**GENERAL
CORRESPONDENCE**

RE: Delegation of Responsibilities Brine Manufacturing Operations

RE: Discharge Plan DP-361

FIGURE 2. Facility layout.
See text for expanded description of each numbered facility.

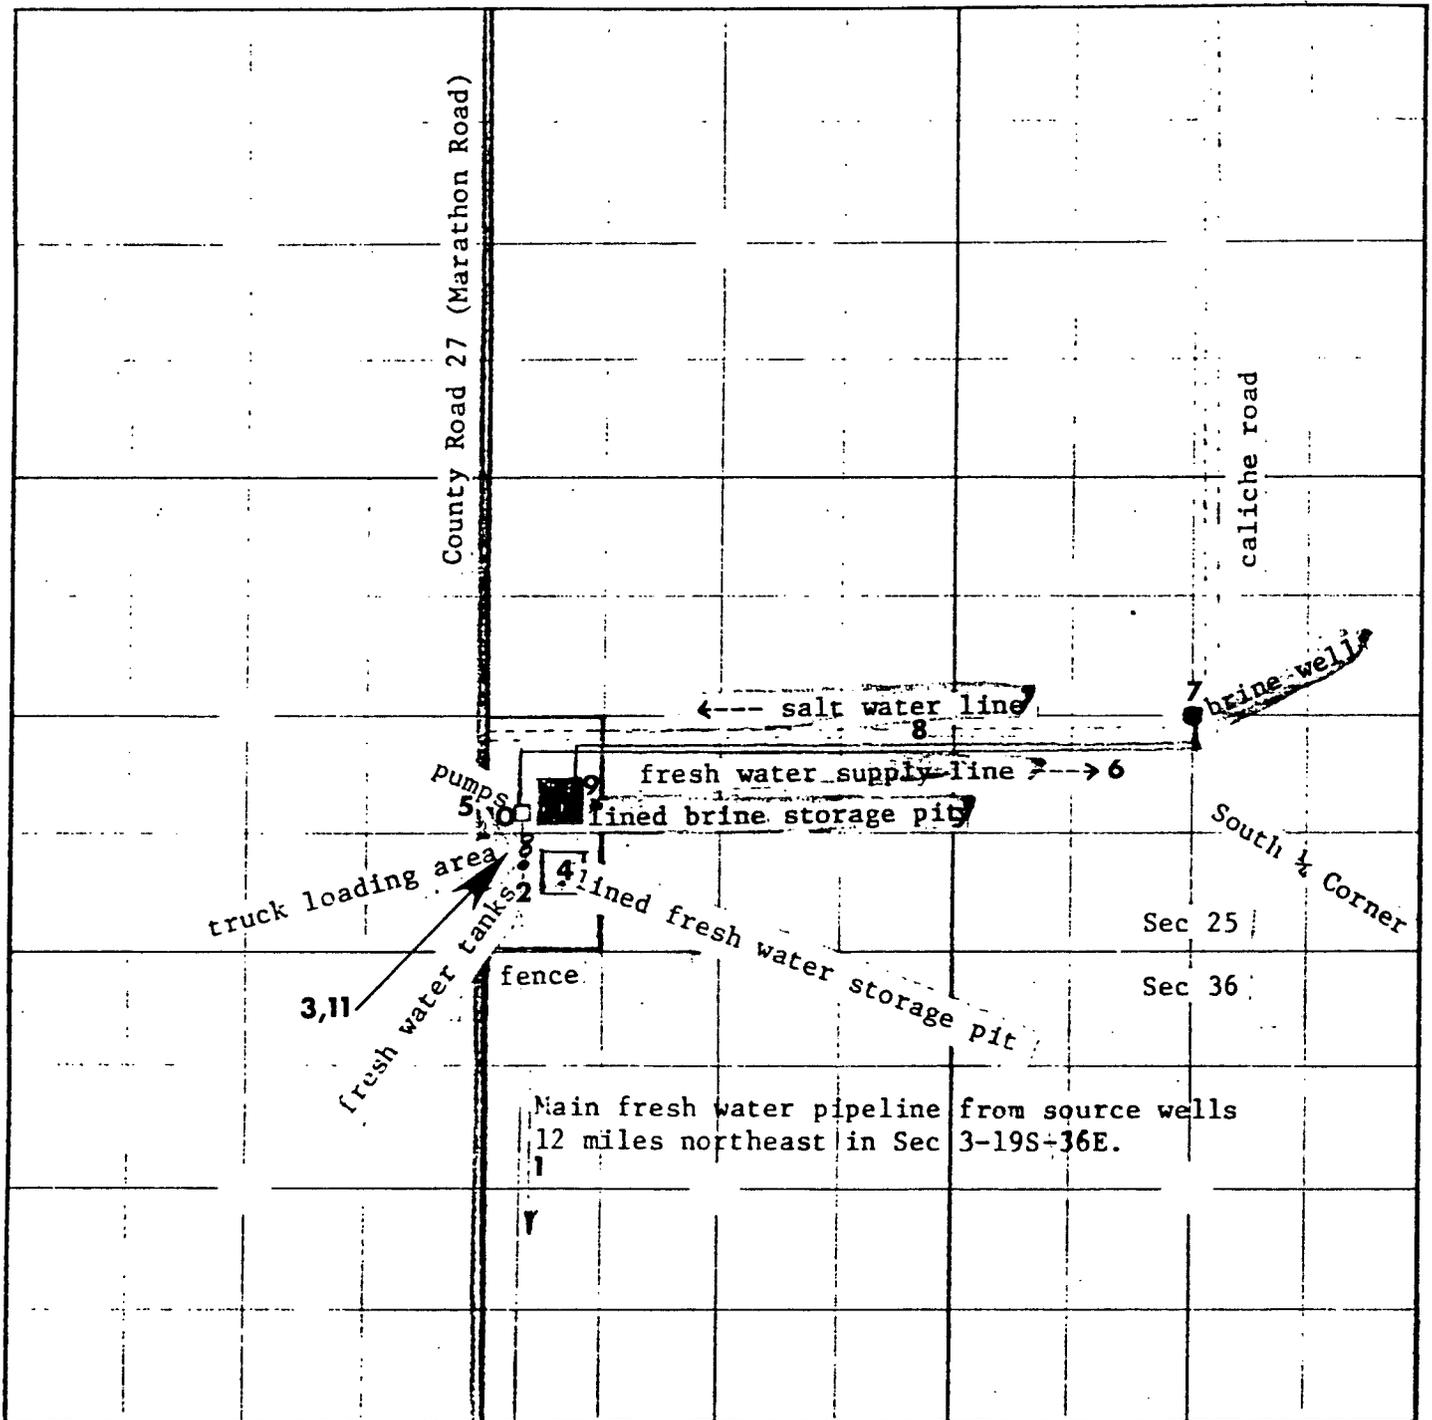
Figure 2 is a map showing the layout of all facilities at the Marathon Road Water Station. Numbers 1 through 11 on the map refer to different facilities. The following verbal description identifies each numbered facility shown in the figure and identifies all current means and locations for measuring water flows which are related to brine activity.
